Specification Change Notice

Brushless Motors and Driver Packages **BMU** Series

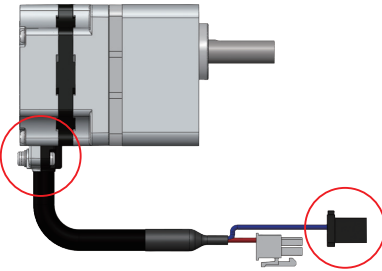
- 1) Sensor connector changes (motor, driver, cable)
- 2) Shape changes of the cable clamps (motor, IP65 type only)
- 3) Degree of protection IP20 → IP40 (motor, standard type only)
- 4) Parameter setting changes (driver)
 - ① Front panel switch operation is disabled (for operations using external signals)
 - ② Initial lower limit value for speed setting range
 - ③ Indication on the panel while the lock function is enabled
 - ④ Indication on the panel while the alarm is activated
